TRANSPORT STATEMENT

Mowbray, North Horsham, West Sussex
Employment Land Road

Appendix D
Stage 1 Road Safety Audit and Response Report

Stage 1 Road Safety Audit

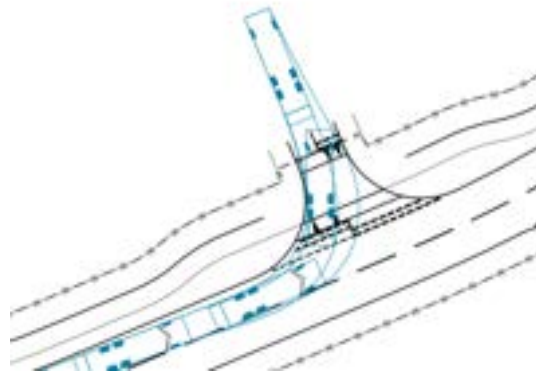
Location: Proposed trees

Summary: Potential impact of trees on visibility splays and safe passage of cyclists/pedestrians

It is noted from the drawings that trees are proposed at various locations throughout the scheme. The Audit Team recognises the aesthetic and ecological value of including these within the proposals. However, if not appropriately located, they could potentially interfere with visibility splays and sightlines at junctions and crossing points.

Any low-hanging foliage or a build-up of leaves/detritus on surfaces could also pose a risk to footway/cycleway users.

It is recommended that the planting of trees within or close to identified visibility splays and sightlines is avoided. It is also recommended that arrangements are put in place for the regular inspection and maintenance of any trees. Tree canopies should be maintained to a suitable height if overhanging a pedestrian/cycle route, whilst sweeping should be undertaken as necessary to ensure surfaces are kept sufficiently clear of leaves and detritus.

2.2	It is recommended that the planting of trees within or close to identified visibility splays and sightlines is avoided. It is also recommended that arrangements are put in place for the regular inspection and maintenance of any trees. Tree canopies should be maintained to a suitable height if overhanging a pedestrian/cycle route, whilst sweeping should be undertaken as necessary to ensure surfaces are kept sufficiently clear of leaves and detritus.	The Design Organisation partially accepts the Audit Team's recommendation. All tree canopies within visibility zones will be maintained at a height no lower than 2m above ground level to maintain clear visibility, and 2.4m above ground level in proximity to cycleways to maintain vertical clearance, whichever is the greater. The roads and footways will be adopted by WSCC in its role as highway authority, who will be responsible for ongoing maintenance, including clearance of leaves. Trees outside highway land will be maintained by a private management company.

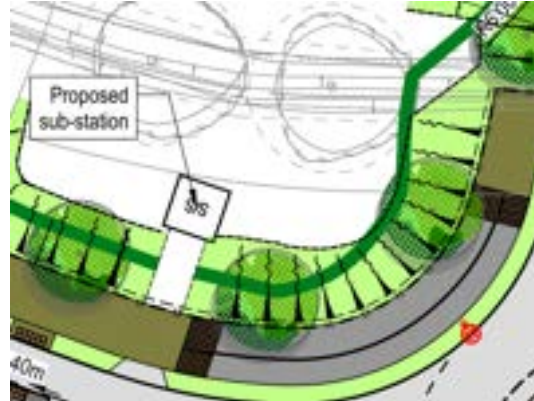
Location: Side road junctions to south of main carriageway

Summary: Crossing points on some junction radii may increase likelihood of vehicle overrun and risk to waiting pedestrians

A number of side road junctions to the south of the main carriageway are to have crossing points located on the junction radii. The swept path information indicates that vehicles may need to pass very close to these crossing points in some cases and particularly at the narrower junctions. With little margin for driver error, it is possible that some vehicles may overrun the dropped kerb line and crossing point. This could pose a risk to any waiting pedestrians.

It is recommended that the proposed arrangement at these junctions is reviewed, and adjusted if necessary, with a view to minimising the likelihood of vehicle overrun and associated risk to pedestrians.

Client:	Legal & General (Strategic Land North Horsham) Ltd
Project:	Mowbray (Land North of Horsham)
Site:	RMA2 - Employment Land General Arrangement Sheet 1 of 3
Engineer & Designer:	Date: October 2024
Checker:	By: 18/10/24
Author:	Author
Drawing No:	MOW-GLA-RMA2-PH2-D-C-1001
Sheet:	P9

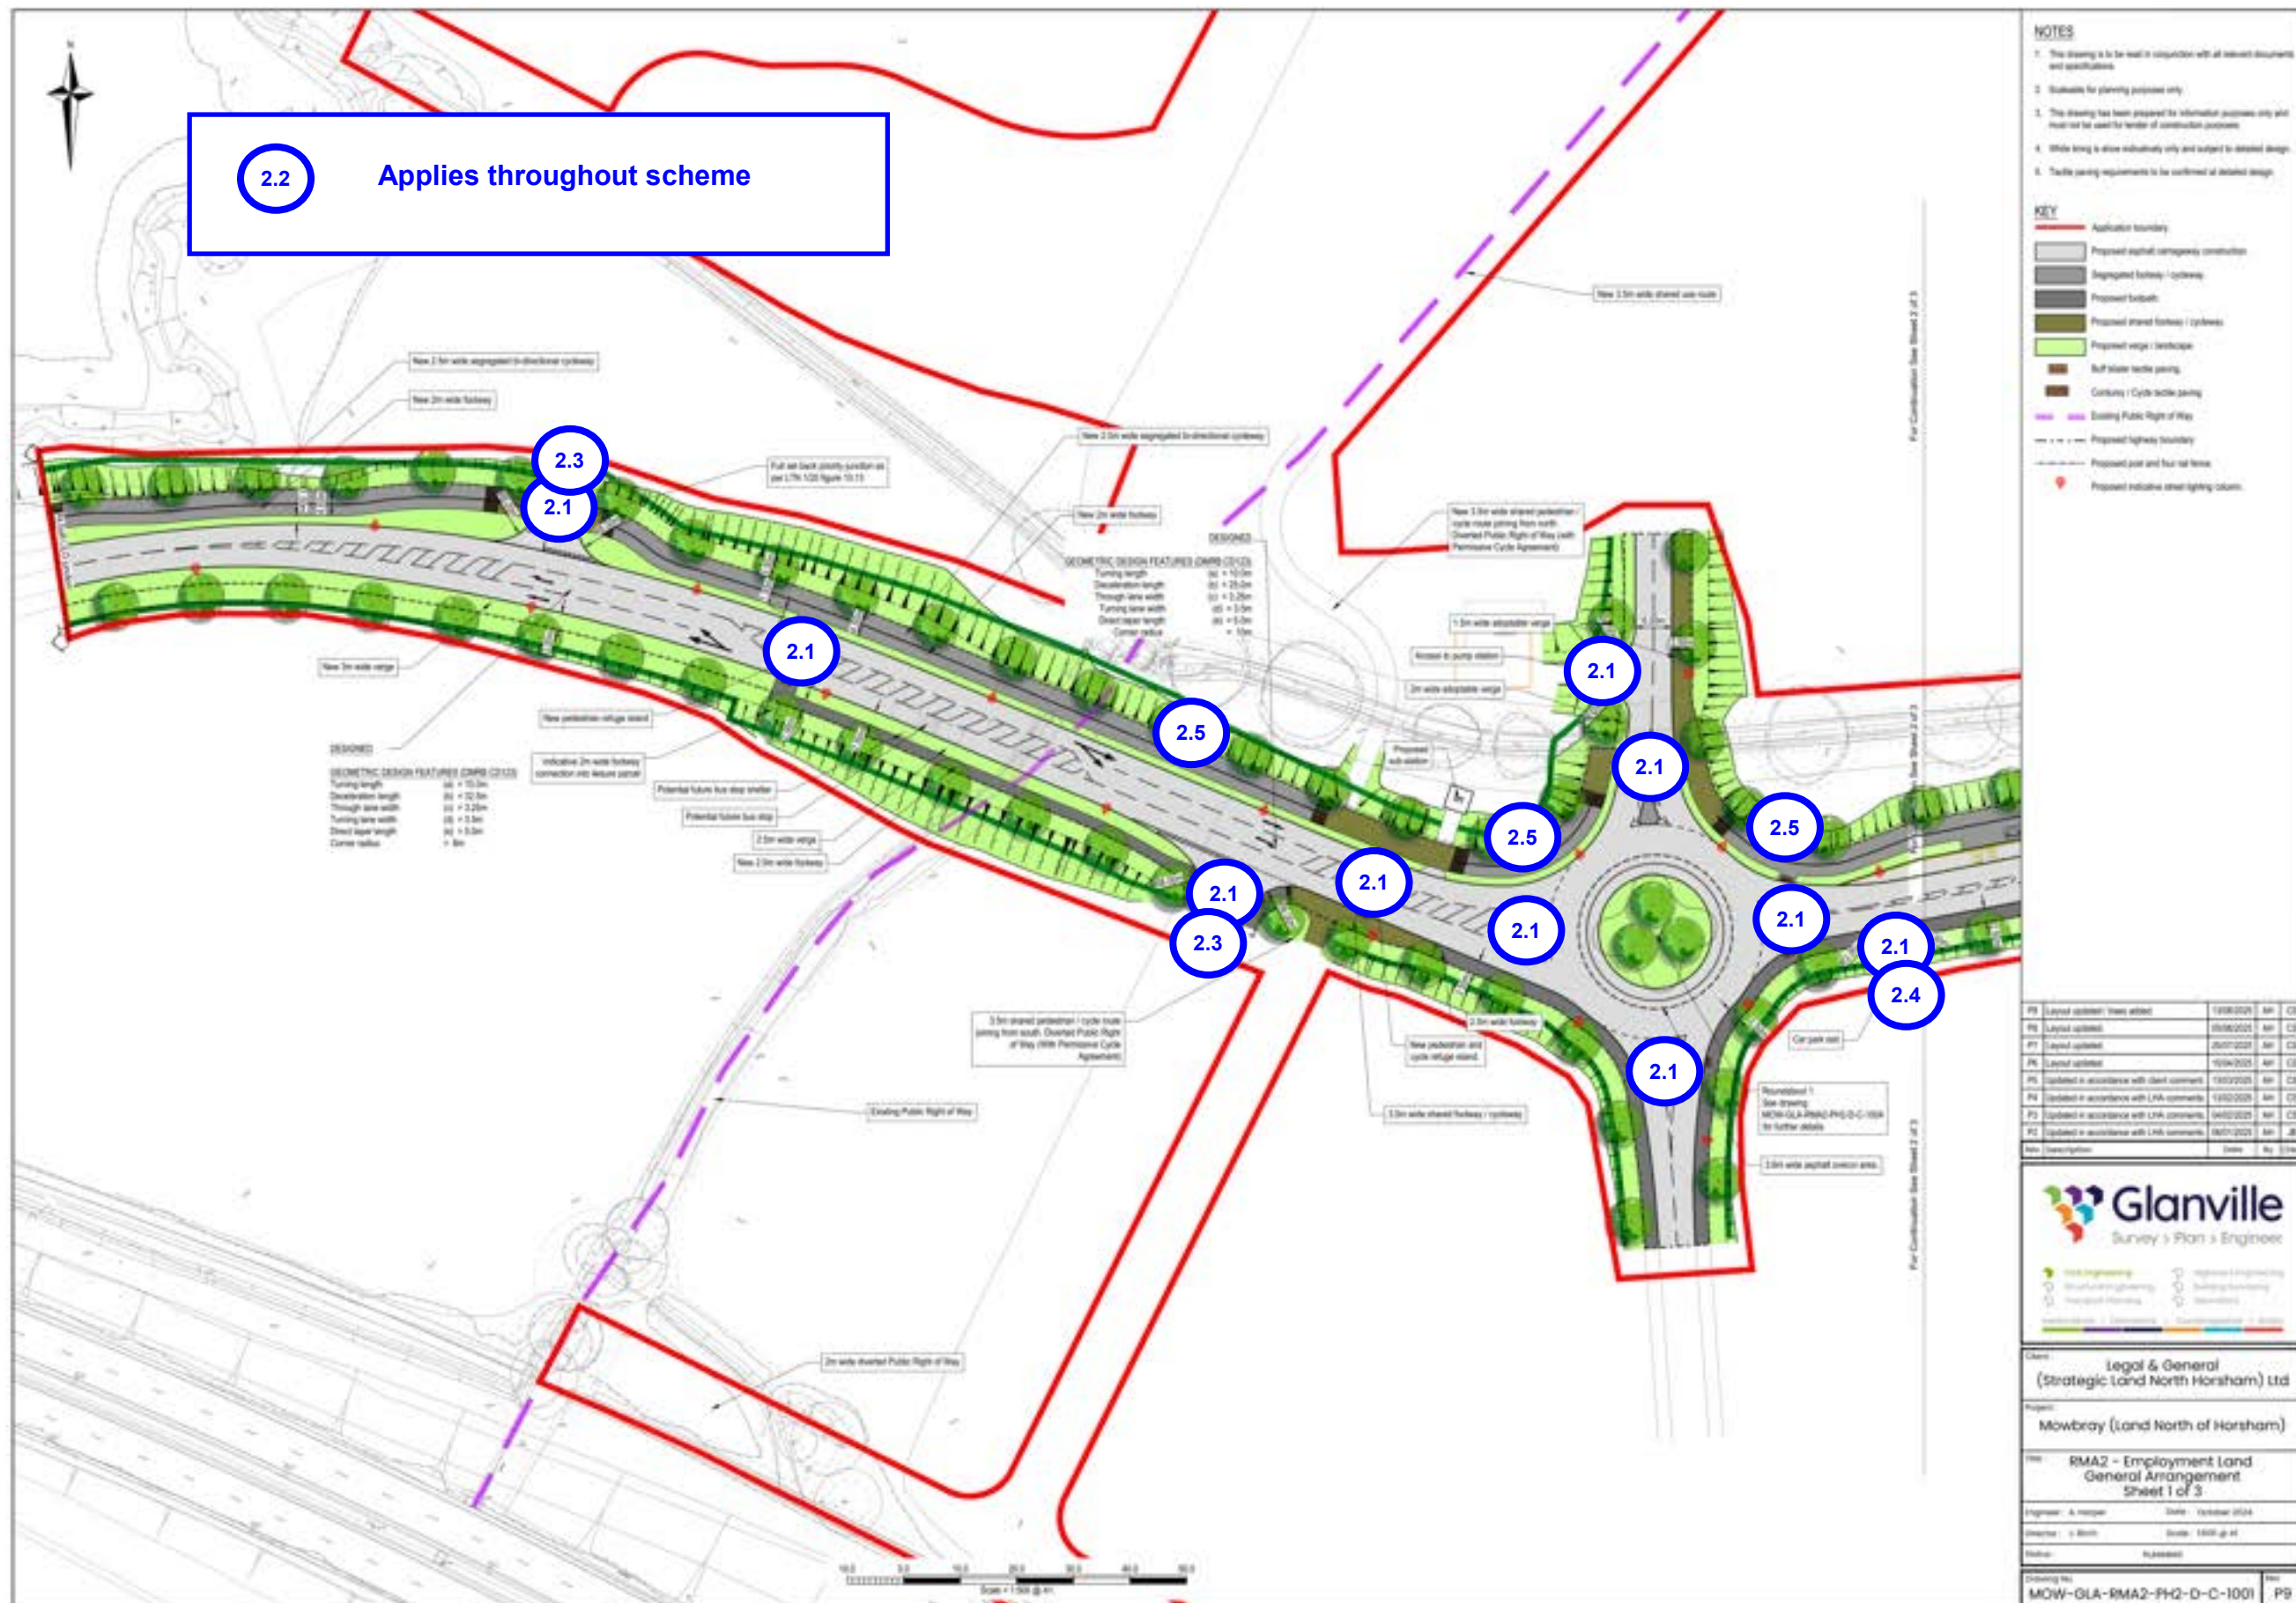
Location: Junctions and crossing points

Summary: Provision of suitable visibility splays and sightlines

In order for the proposed arrangement to operate safely, it will be important that users have sufficient visibility of one another. This includes at junctions and at pedestrian/cycle crossing facilities. If visibility is inadequate at these locations, this could lead to a heightened risk of associated collisions.

It is recommended that appropriate visibility splays/sightlines are identified at all junctions/crossing facilities and kept clear of obstruction.

RSA Problem	RSA Recommendation	Design Organisation's Response	Overseeing Organisation's Response	Agreed RSA Action
2.1	It is recommended that appropriate visibility splays/sightlines are identified at all junctions/crossing facilities and kept clear of obstruction.	The Design Organisation accepts the Audit Team's recommendation. Visibility splays of 2.4m x 17m (LTN 1/20 for 20kph) have been provided from any direct accesses which front onto the shared use facility.

Drawing No: MOW-GLA-RMA2-PH2-D-C-1003 Rev: P10

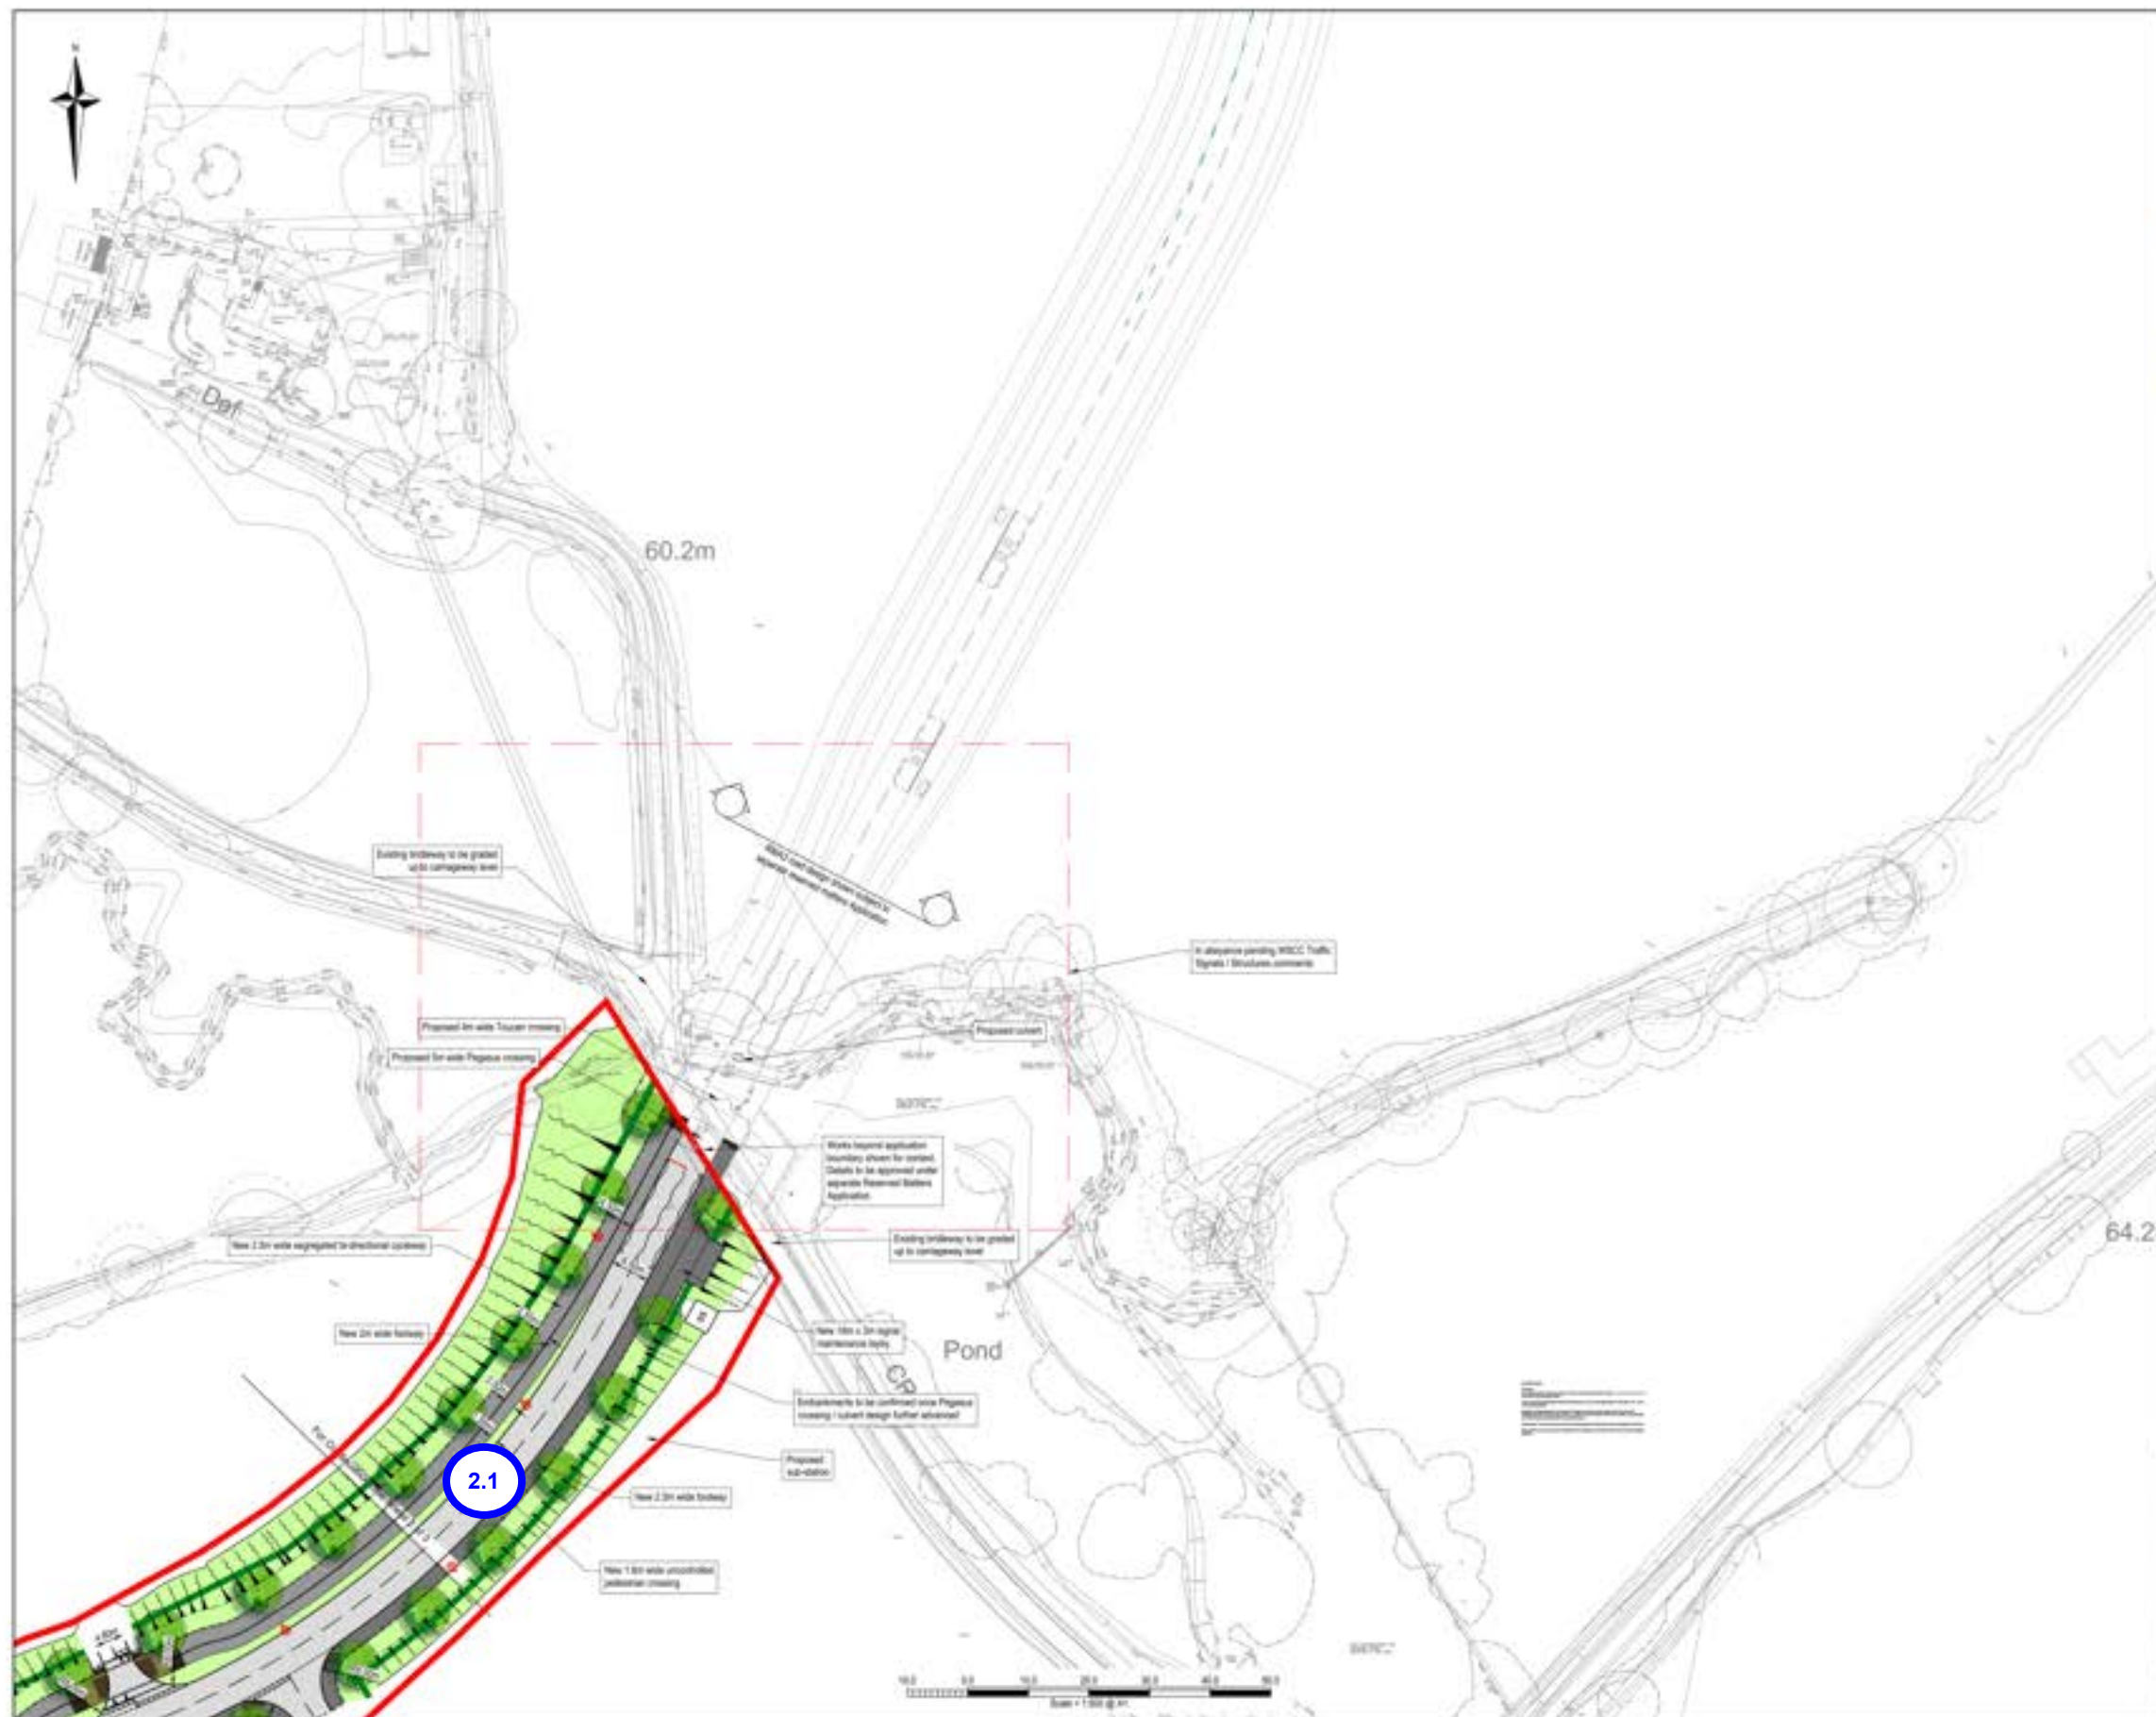
Location: Cycleways to north of main carriageway

Summary: Slopes/gradient adjacent to cycleway could pose a risk to users

It appears from the drawings that there will be an adjacent slope very close to some sections of new cycleway. Depending on the severity/gradient, cyclists could be at risk if they were to veer slightly from the cycleway surface. This could be a particular risk during the hours of darkness, when any adjacent slopes may be less obvious to users.

It is recommended that the likely severity of any slopes is assessed and additional measures to protect cyclists introduced if appropriate. It is noted that post and rail fence or a 'buffer verge' is proposed at some locations. A similar measure could be applied elsewhere if necessary.
